Pedestrian Crossing of Cycleways – need for legibility and consistency

In the latest papers for the Transport and Connectivity Policy Committee on 20th March 2025, plans for new segregated cycleways are included in three of the major road scheme proposals:

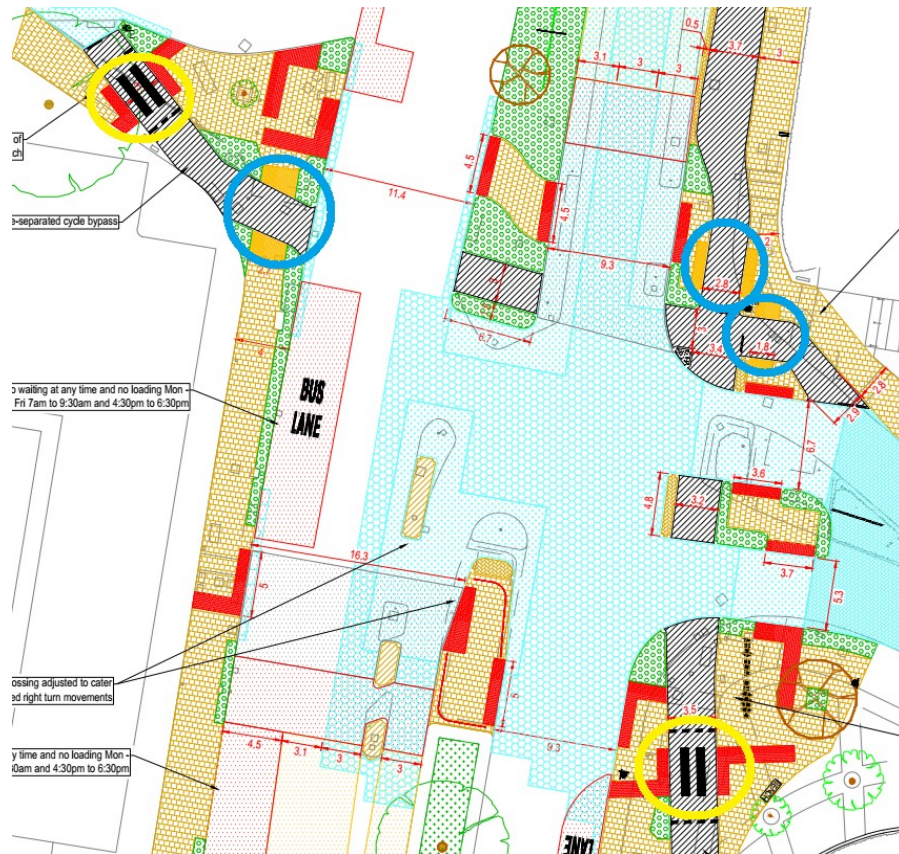
For example, in the Route 2 Corridor scheme there are five crossings in close proximity on the pedestrianised area **where Richmond Hill and Park Place meet Queens Road** (see diagram). Three of these have zebra markings (circled in yellow) but two don't (circled in blue).

We advocate that where a pedestrian desire line crosses a cycle track in a pedestrianised area, there should always be zebra markings. It then becomes clear that cyclists and e-scooter users should give way to pedestrians, corresponding to the road user hierarchy of modes set out in national policy, including the Highway Code, and in the Joint Local Transport Plan 4.

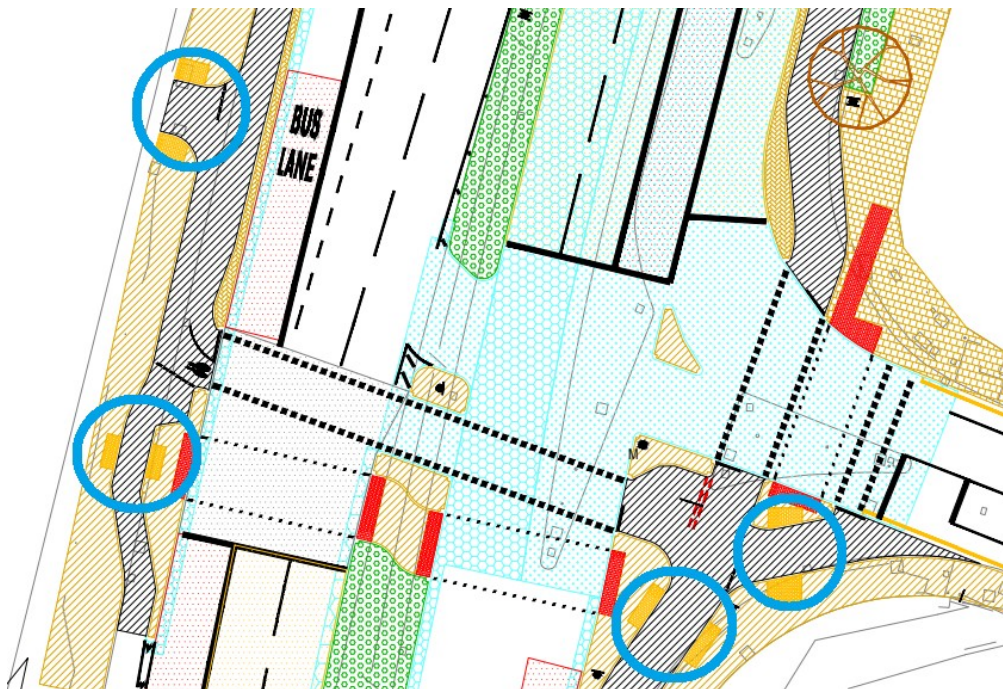
Taking an example from the **Temple Way** scheme at the junction with **Temple Back East** again shows two crossings with zebra markings (circled yellow) and three without (circled blue).

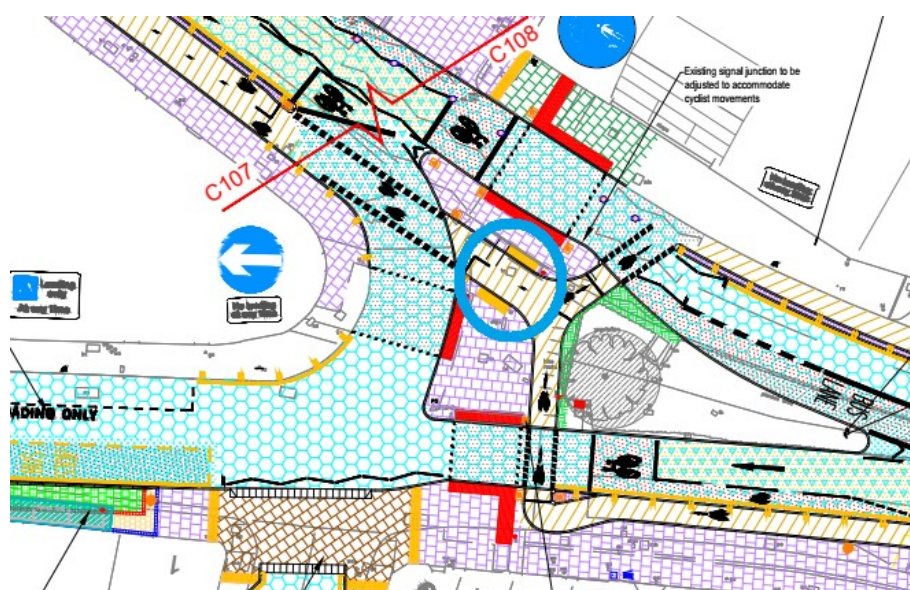
So it appears that the current designs have chosen to make some crossings 'pedestrian priority' and given them zebra markings and red tactile paving, but other crossings are presumably not 'pedestrian priority' and have no markings, but they are clearly crossings because they retain buff tactile paving on either side.

The choice of whether a crossing is 'pedestrian priority' or not in the three schemes seems arbitrary. It certainly does not follow the LTN 1/20 guidelines because several of the unmarked crossings cross two-way cycle tracks, which should therefore have zebra markings.
